April 26, 2022
Medway Planning & Economic Development Board
Meeting

Public Hearing Continuation
Phytopia – 6 Industrial Park Road
Site Plan, Reduced Parking Special
Permit and Groundwater Protection
Special Permit

**Subject: Response to October 27, 2021 review comments from Tetra Tech
Phytopia, Inc.
Major Site Plan Review
6 Industrial Park Road
Medway, Massachusetts**

**Re: Phytopia Inc.
 Major Site Plan Review
 6 Industrial Park Road
 Medway, Massachusetts**

SHEET 10 OF 14

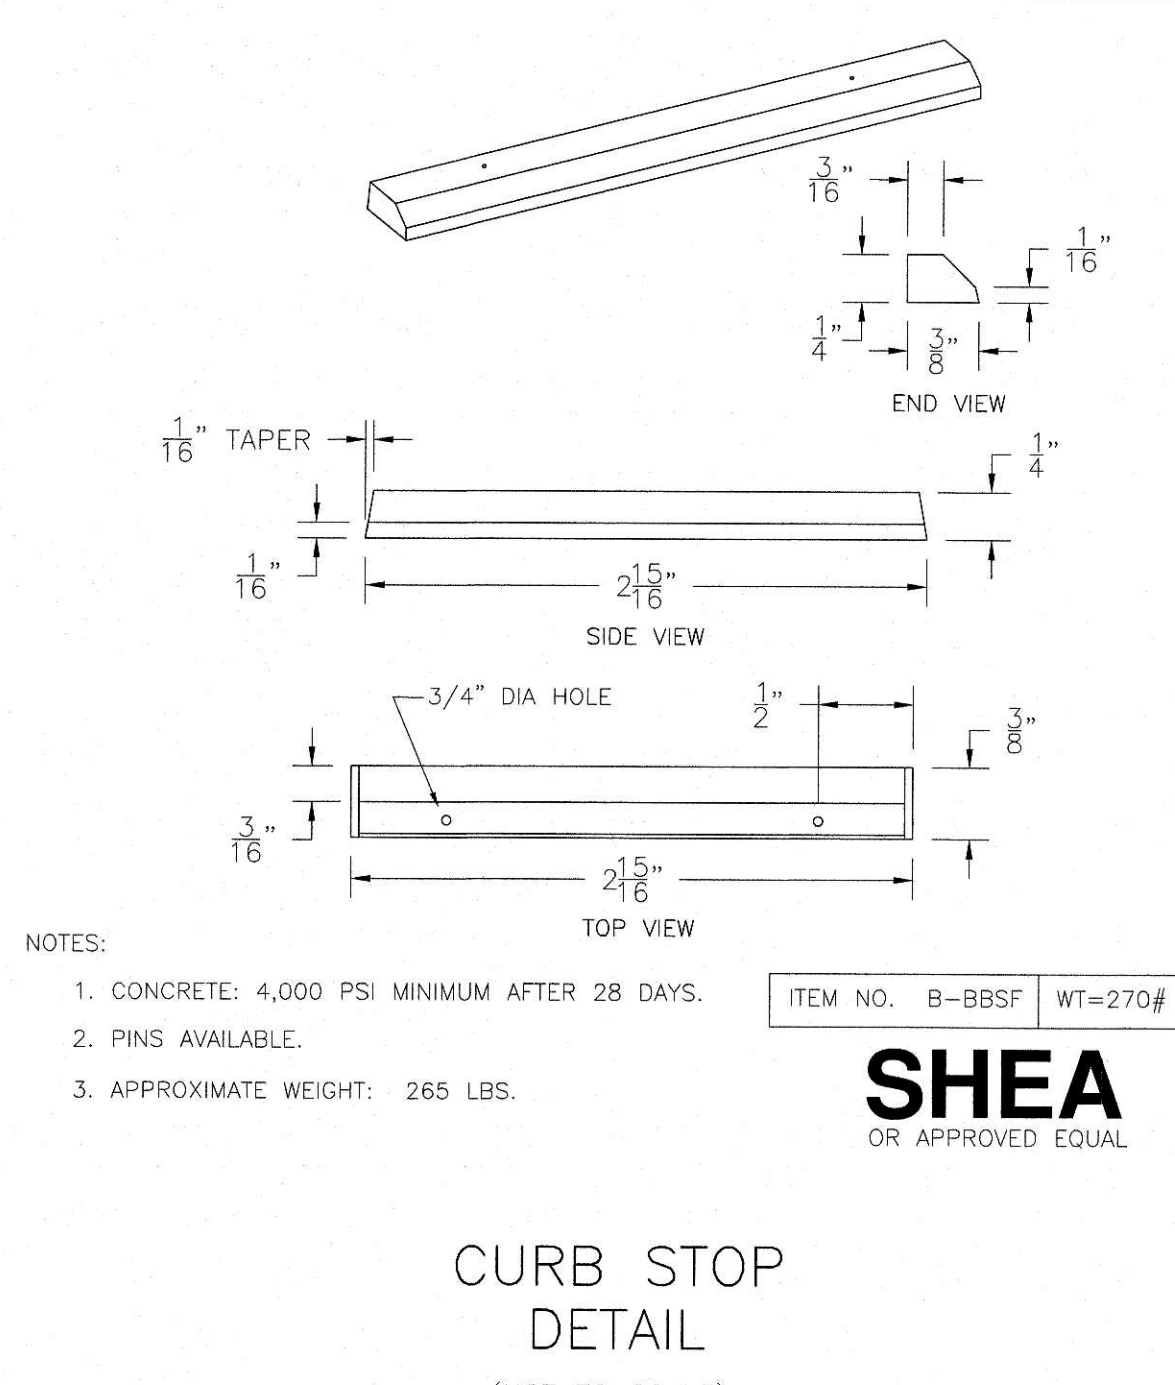
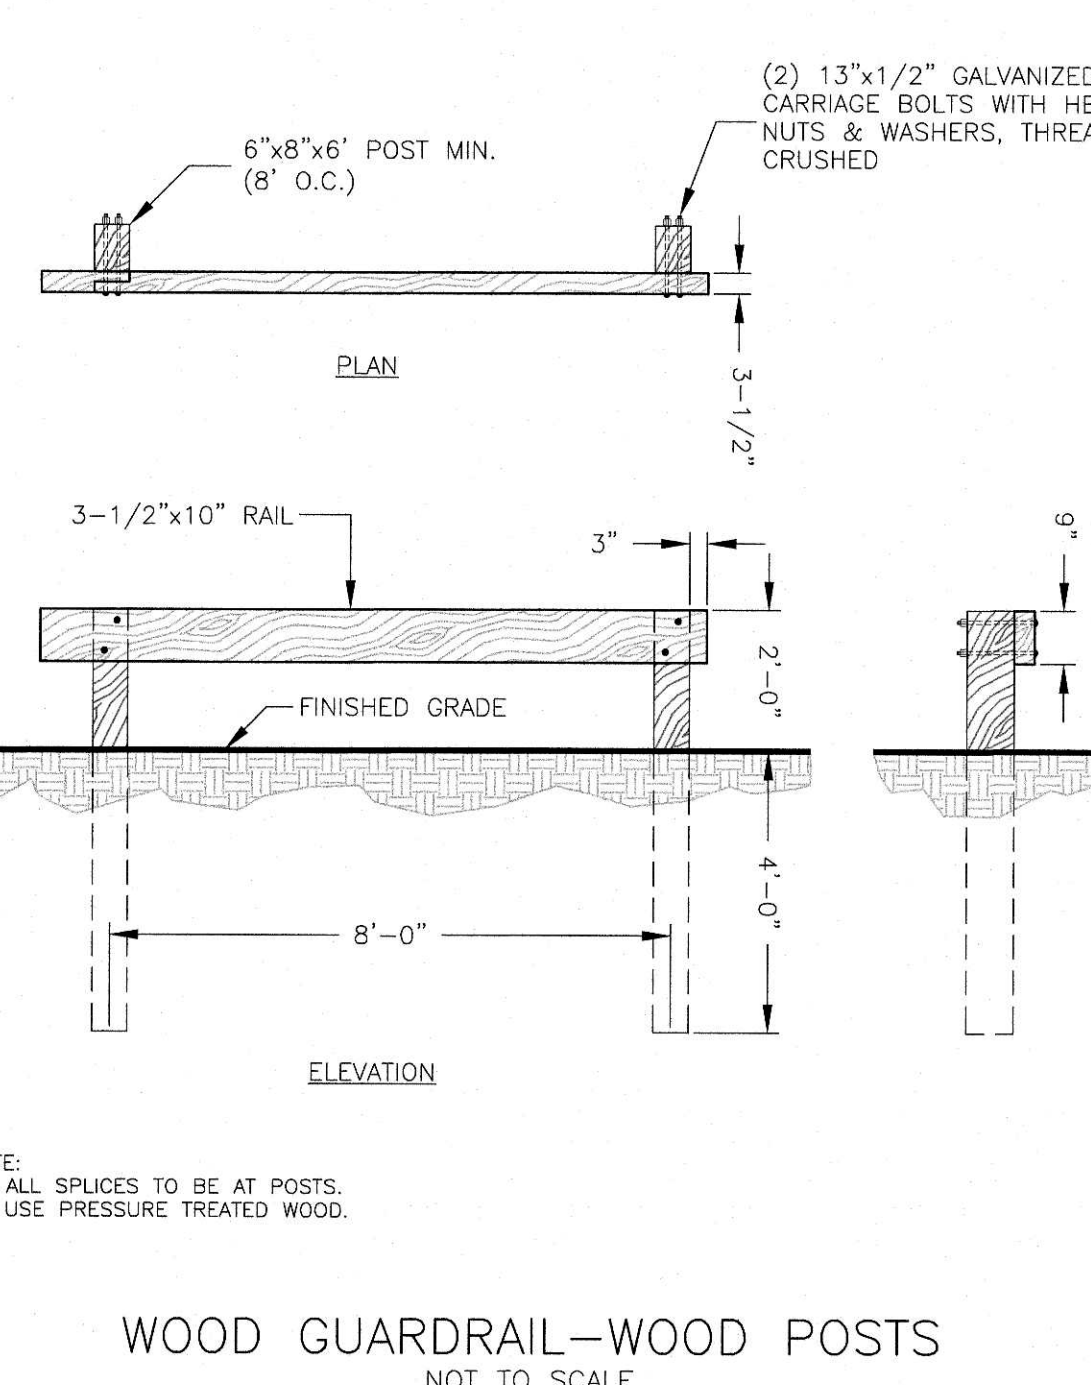
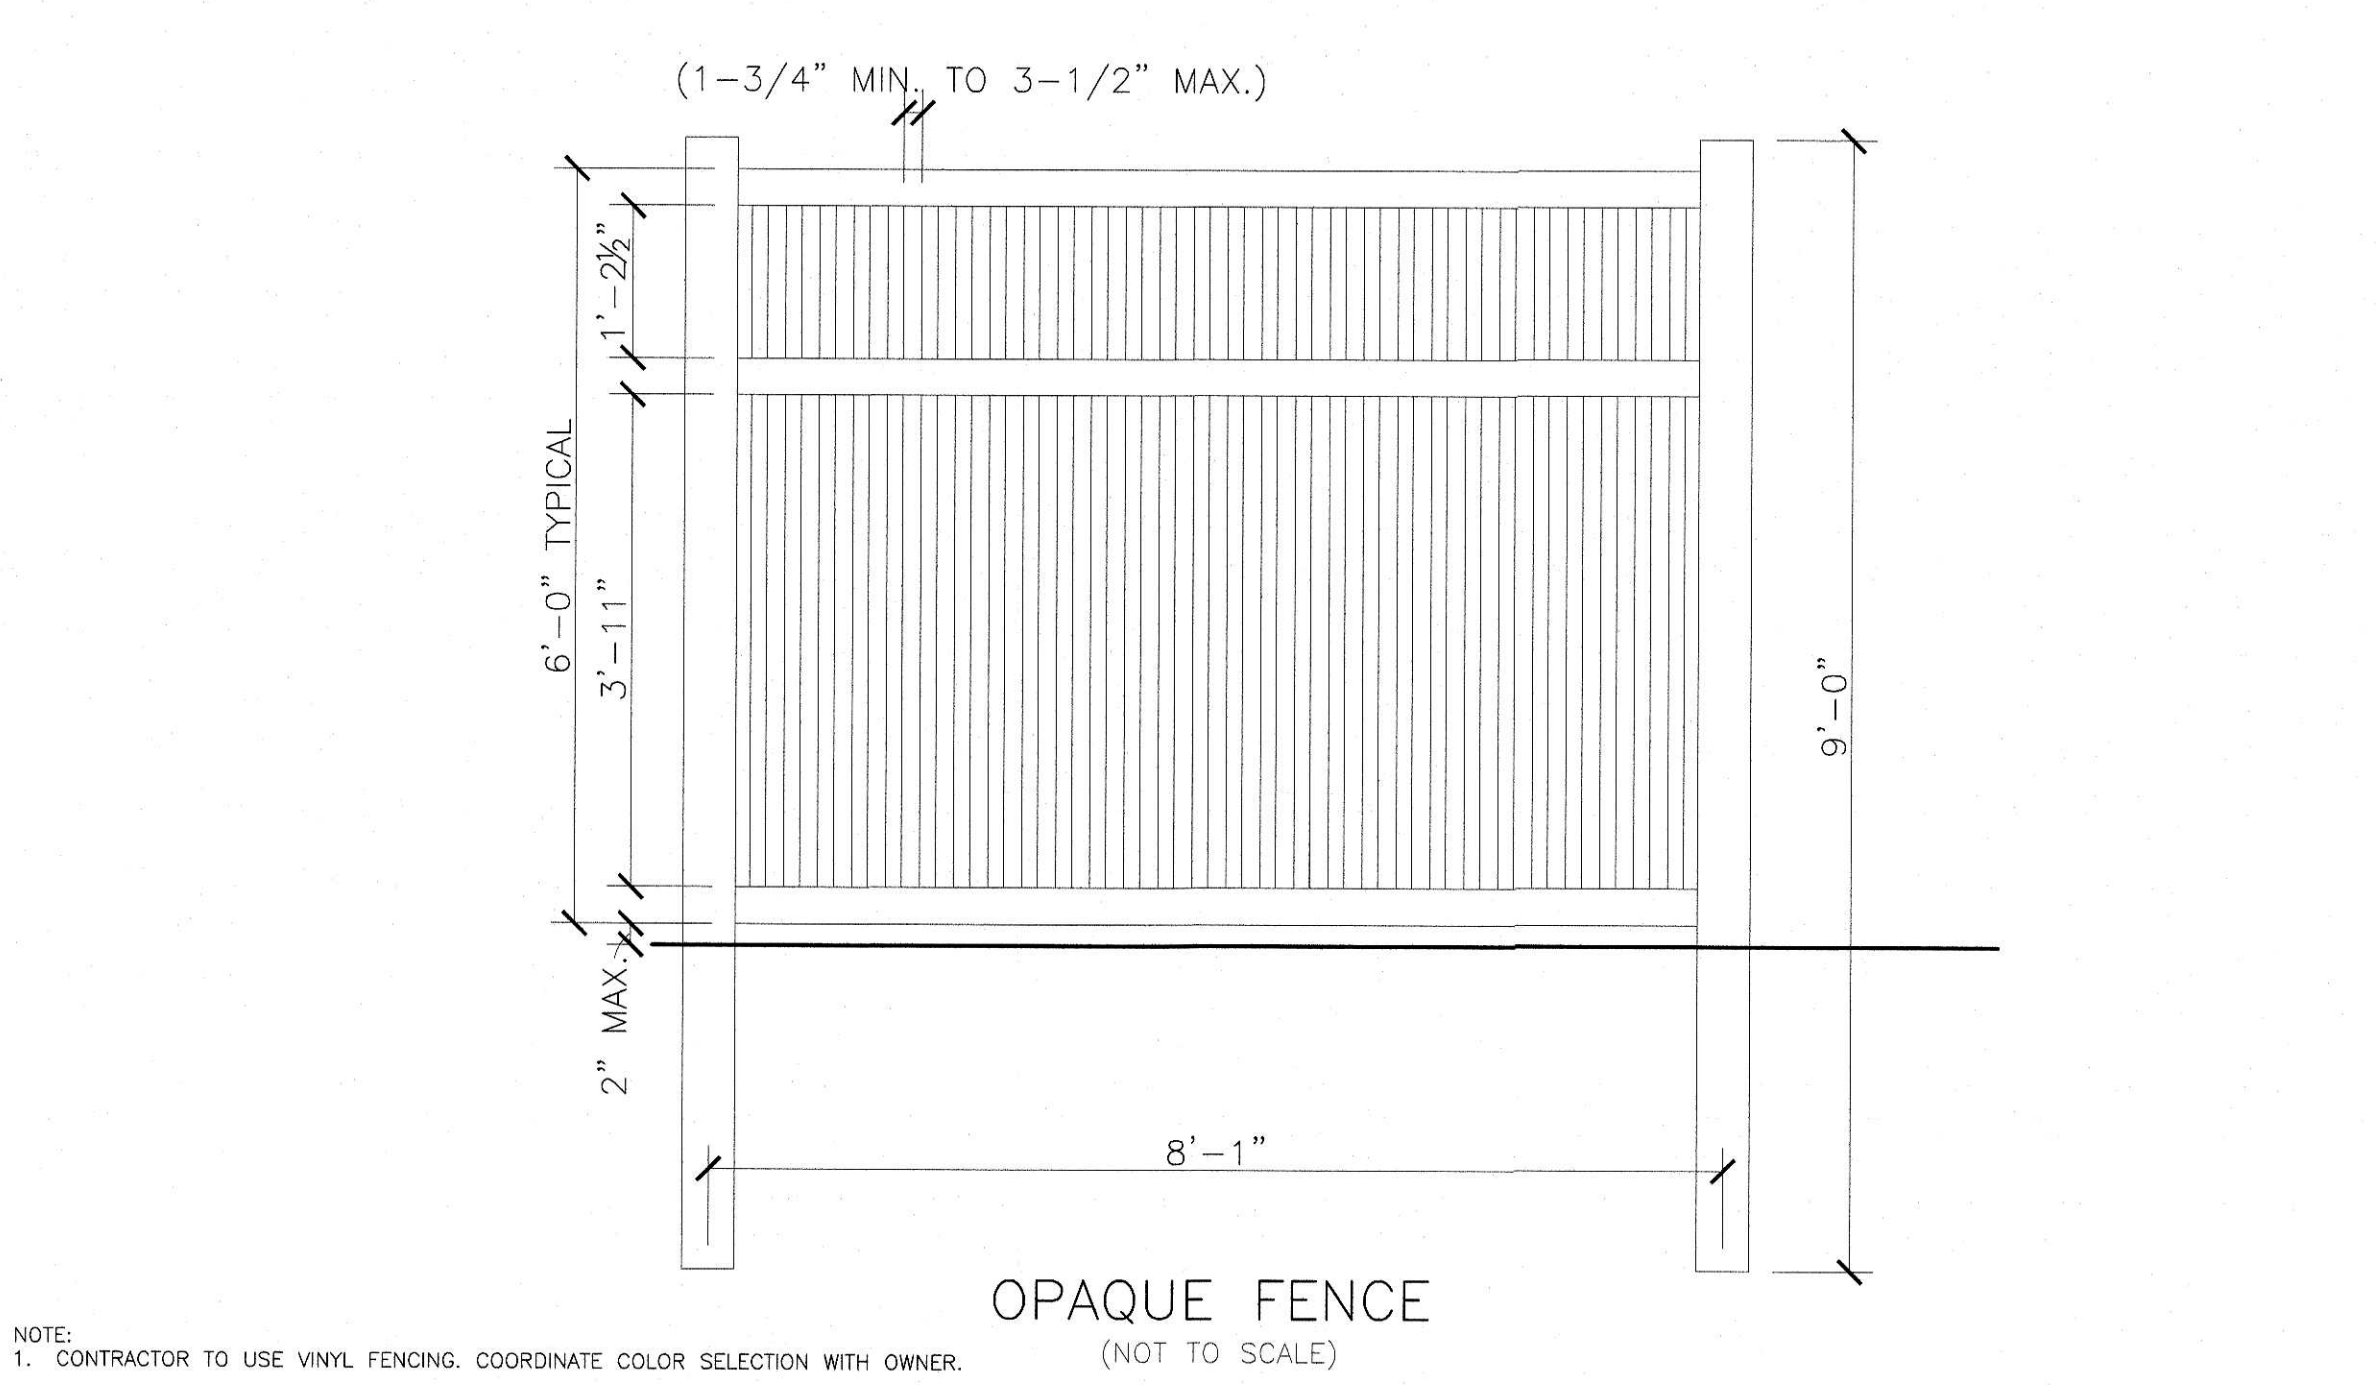
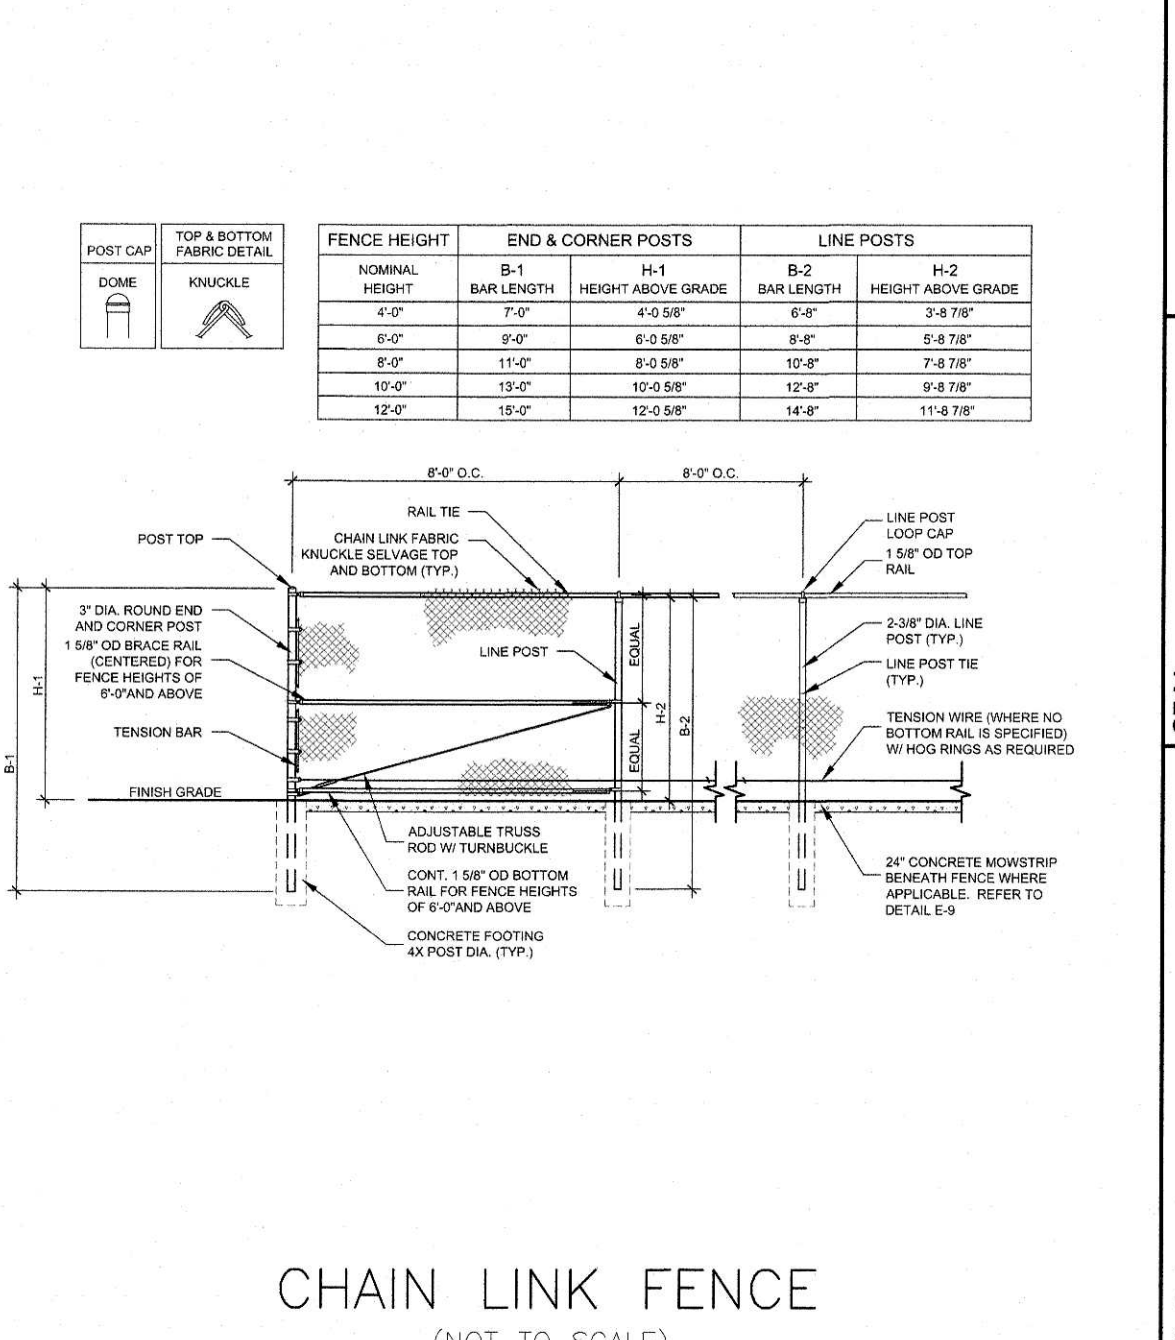
37. Mulch sock should be depicted in the "Siltfence with Mulch Sock" detail on the Construction Details Plan.

TT 10/27/21 Update: The detail does not appear to be correct as certain information is missing on the detail or is not showing up correctly when printed from CAD.

37. Mulch sock should be depicted in the "Siltfence with Mulch Sock" detail on the Construction Details Plan.
- *WSE 10/12/21 Response: Mulch sock is depicted on the Construction Details Plan, see sheet 9.*

The detail has been corrected. See sheet 10 of the plan set.

- *WSE 4/12/22 Response: The detail has been corrected. See sheet 10 of the plan set.*
 - **TT 4/22/22 Update: In our opinion, this comment is resolved.**
